# Addendum Number 01

To Drawings and Specifications dated March 10, 2024

**2024 Watkins & Rowe MS and Cy Park HS Renovations**  
**Cypress Fairbanks Independent School District**  
**CFISD Proposal Number: 24-02-5753-R-RFP**

PBK Project No's.: 240058/240059

18 ORCHESTRA EXT. ELEVATION - WEST  
3/16" = 1'-0"

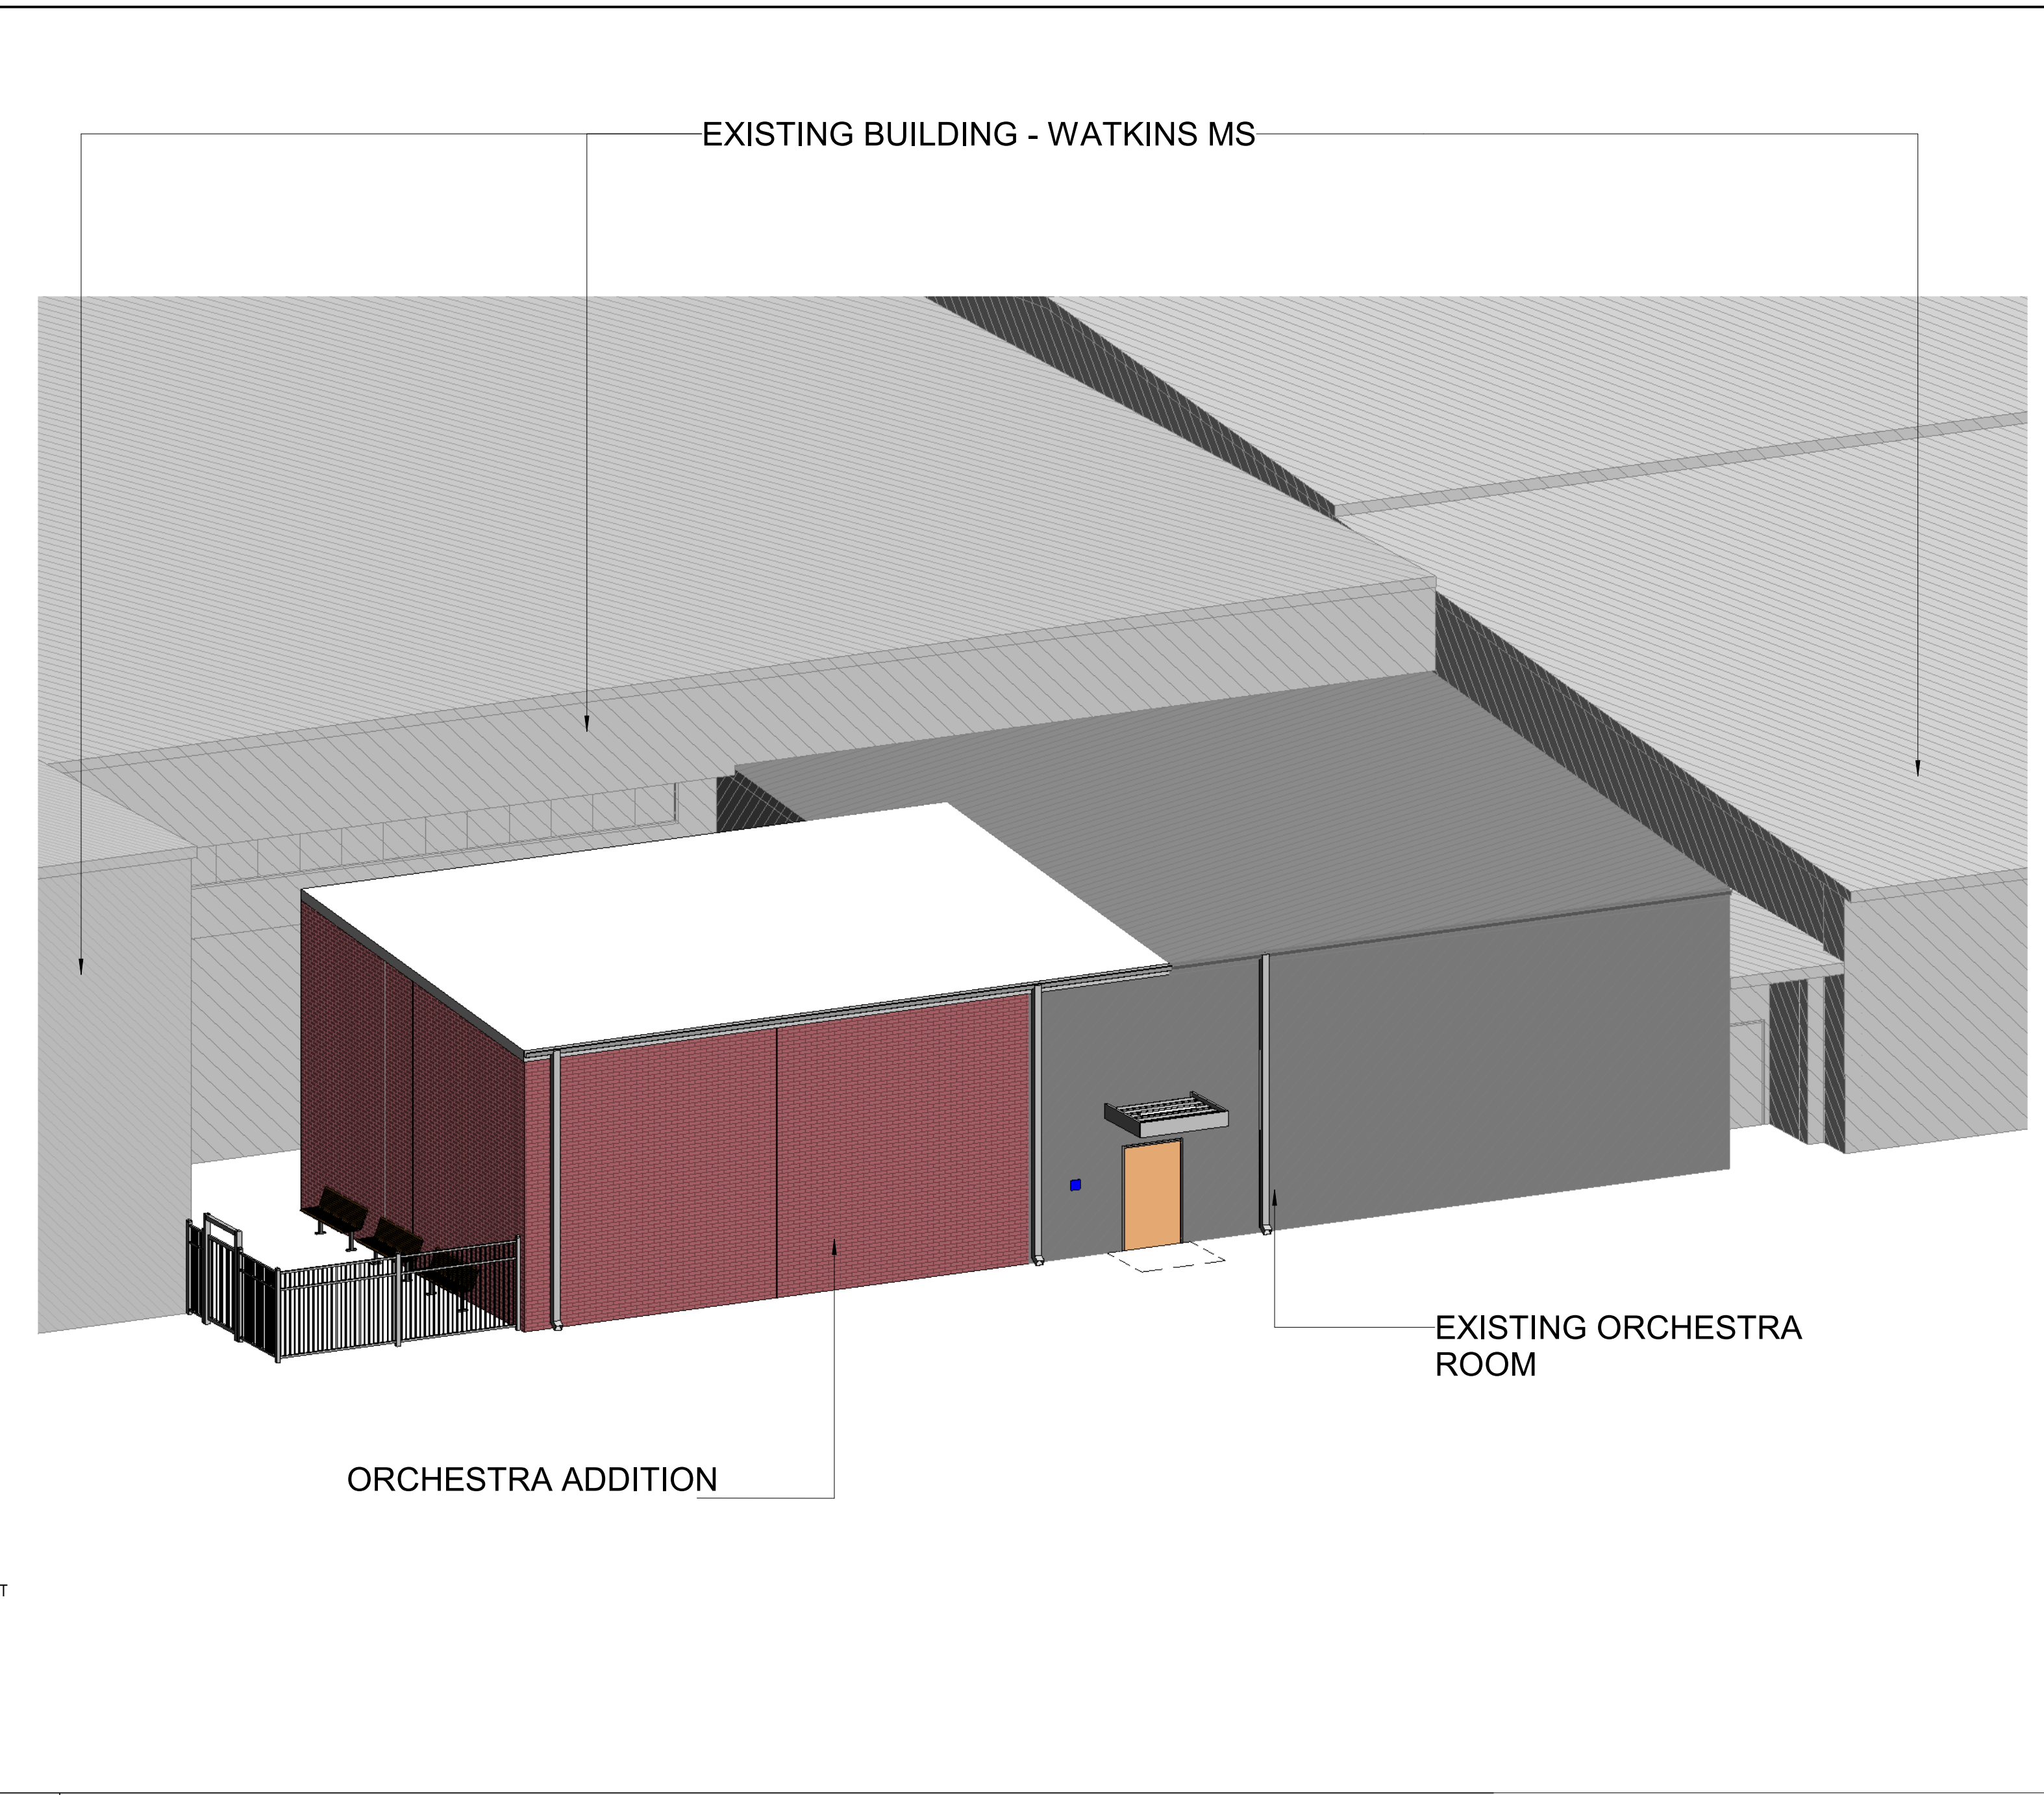
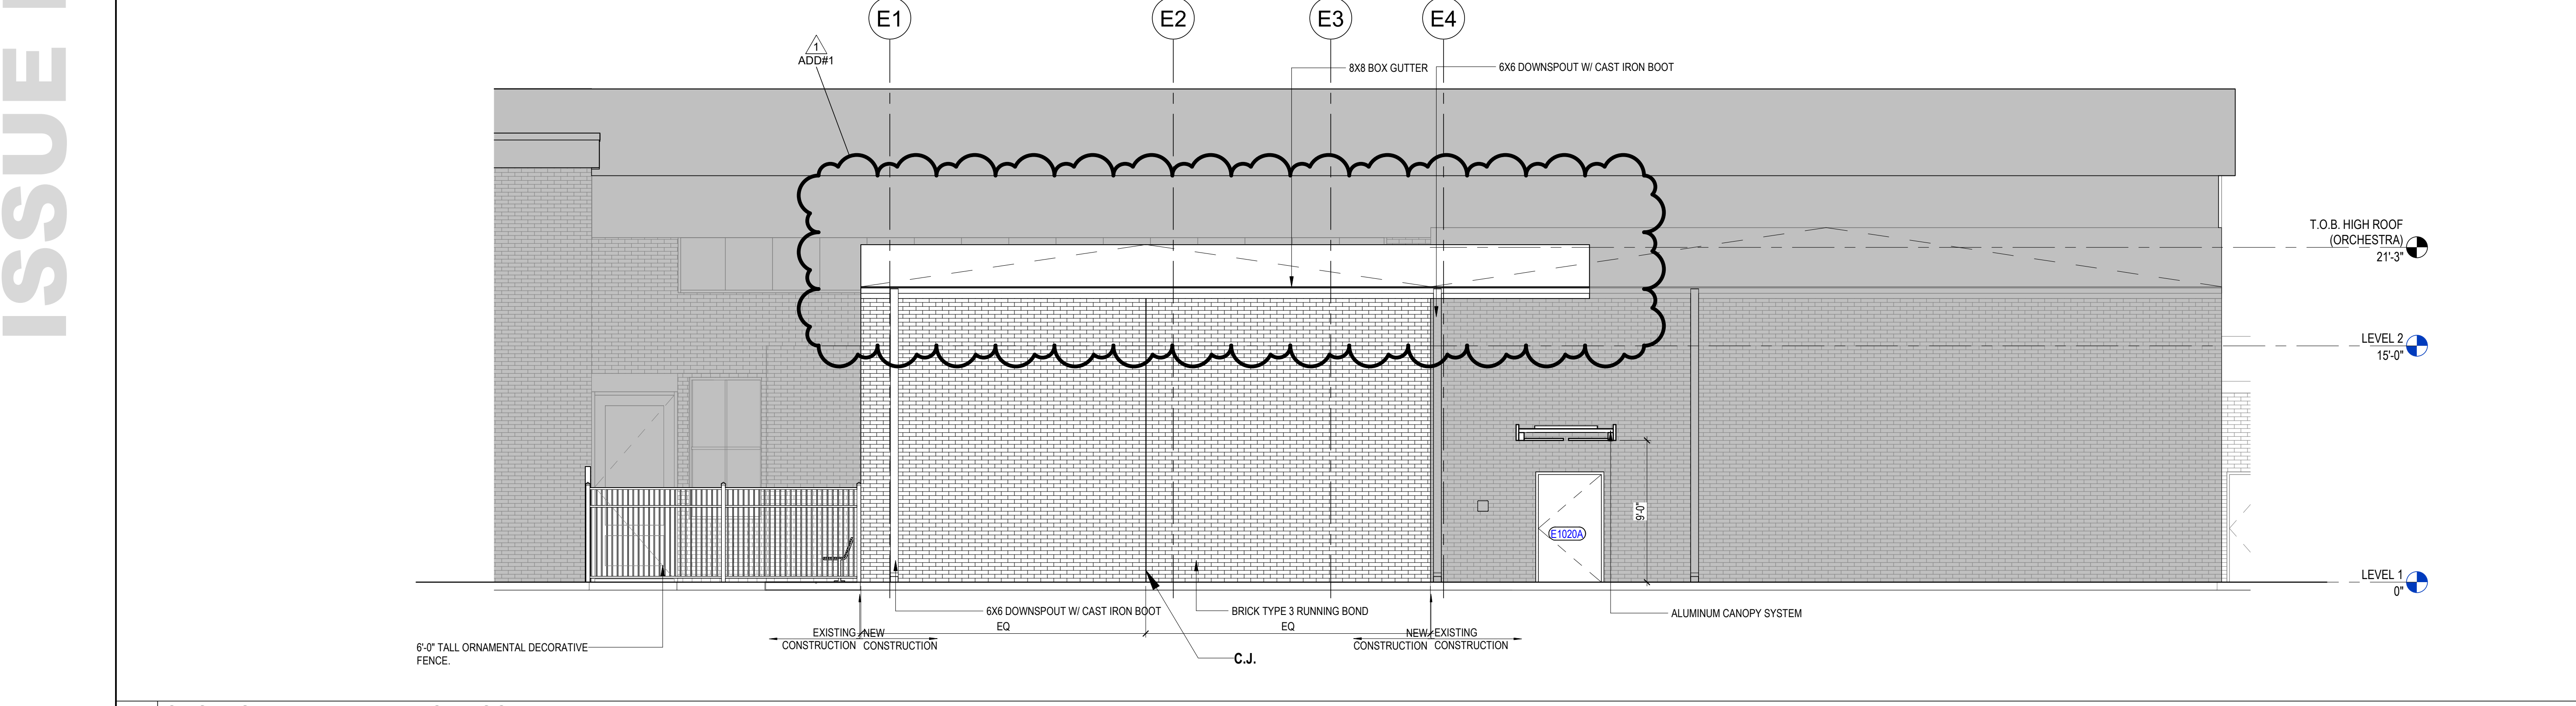
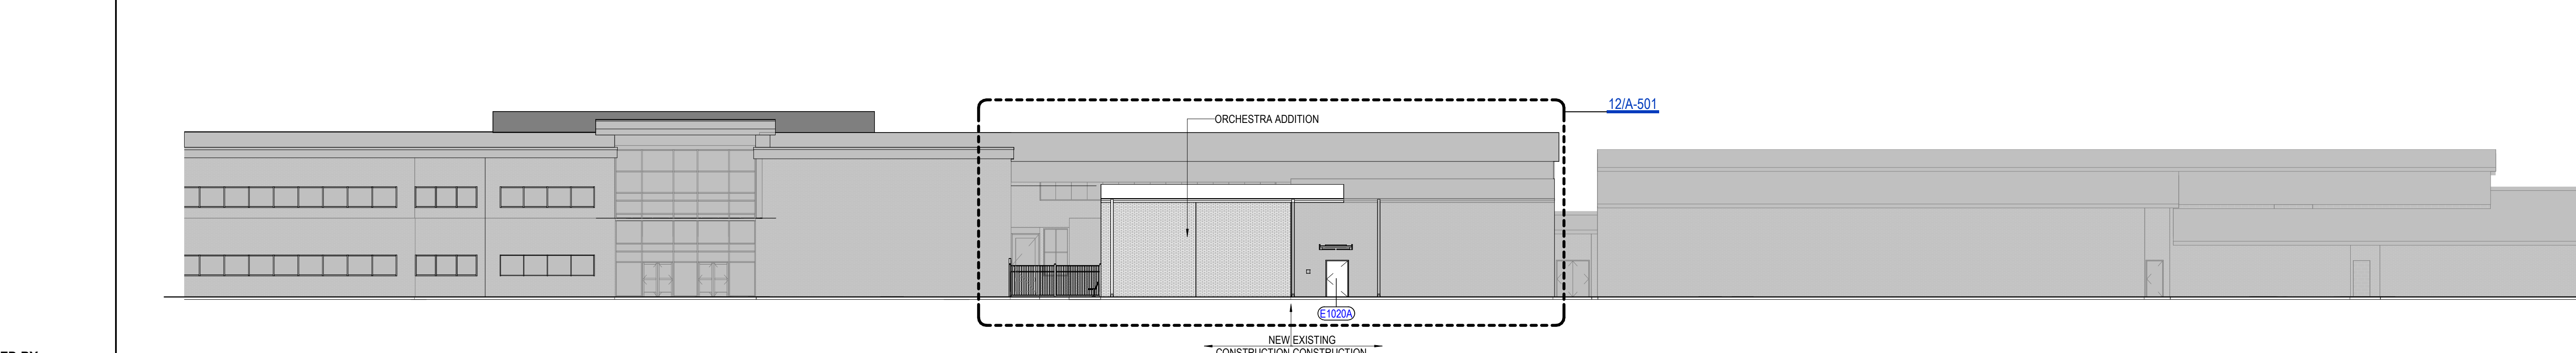
- Item No. 16** Sheet A-501 - EXTERIOR ELEVATIONS – ORCHESTRA ADDITION
  - A. Extents of new roof graphically clarified on Details 26, 12, & 06.
  - B. Detail 18 Orchestra Ext. Elevation: added keynote 32 33 00.BB2 to benches

**Branch Panel: LMA** NEW PANEL

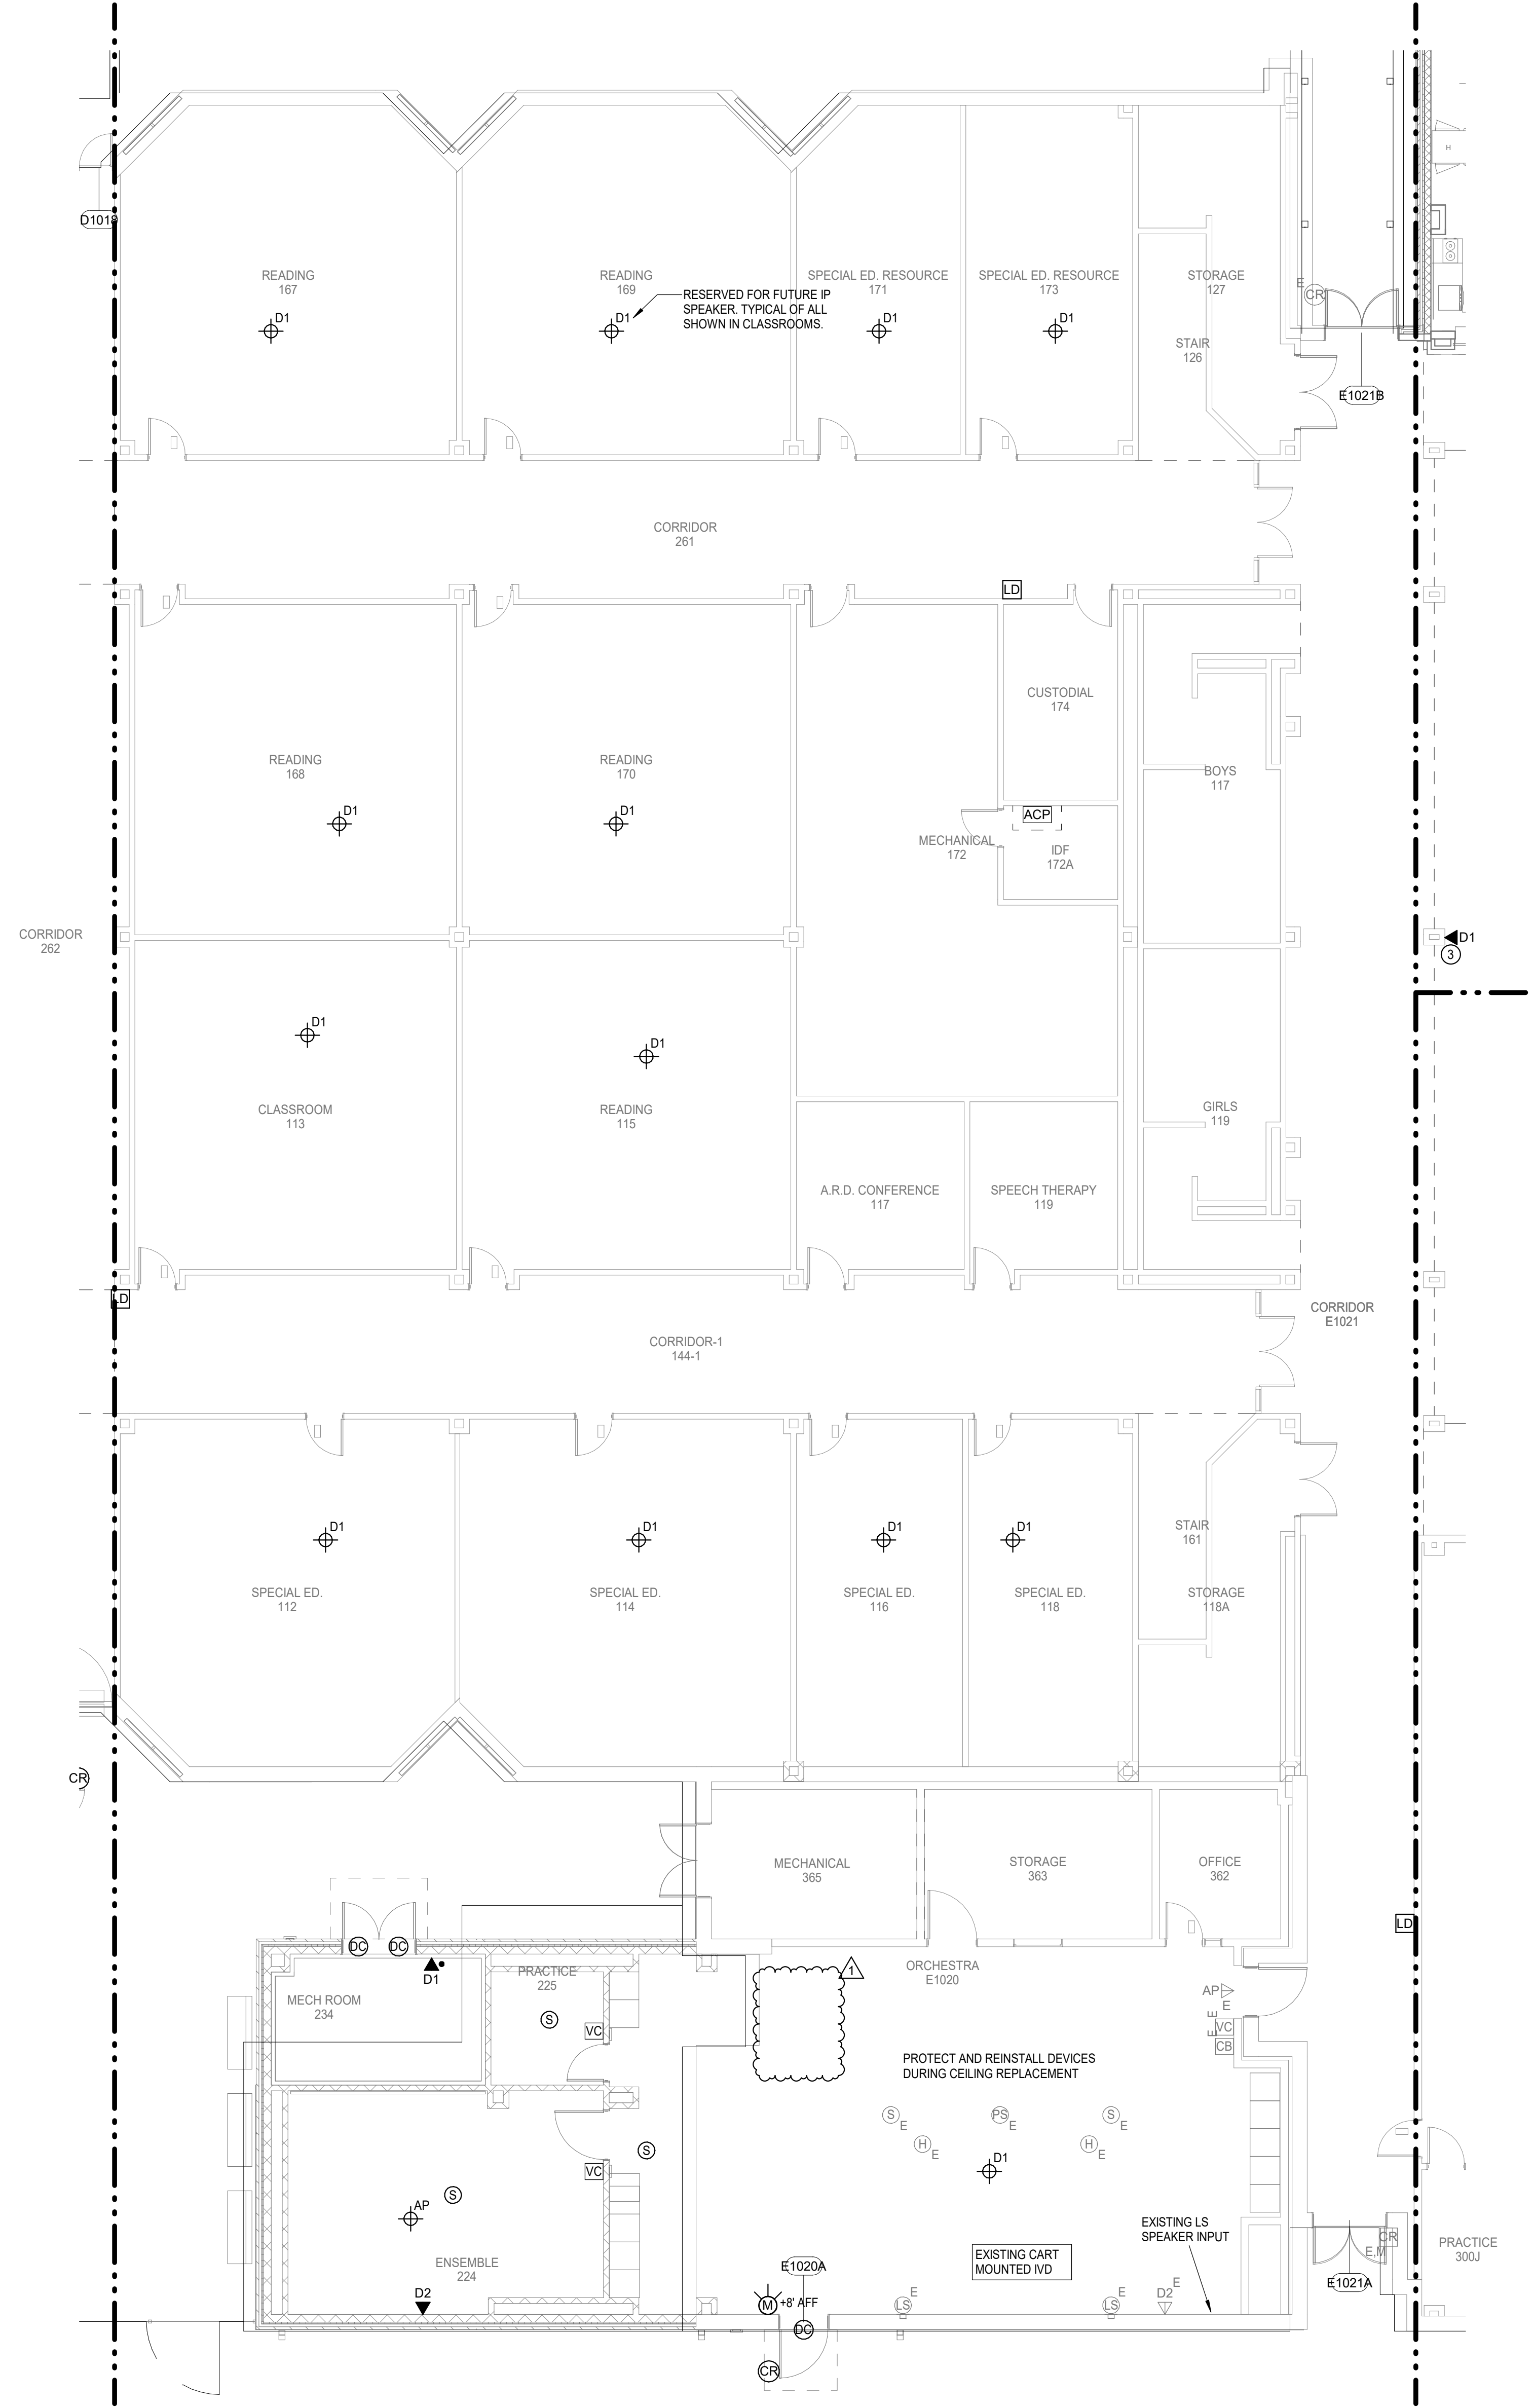
- A. Replace CKT 10 and CKT 12 with spare 20A breaker.
- Item No. 23** T-002 – TECHNOLOGY DEMOLITION FLOOR PLAN – LEVEL 1 – AREA E
  - A. Orchestra E1020, update motion detectors to existing be demolished.
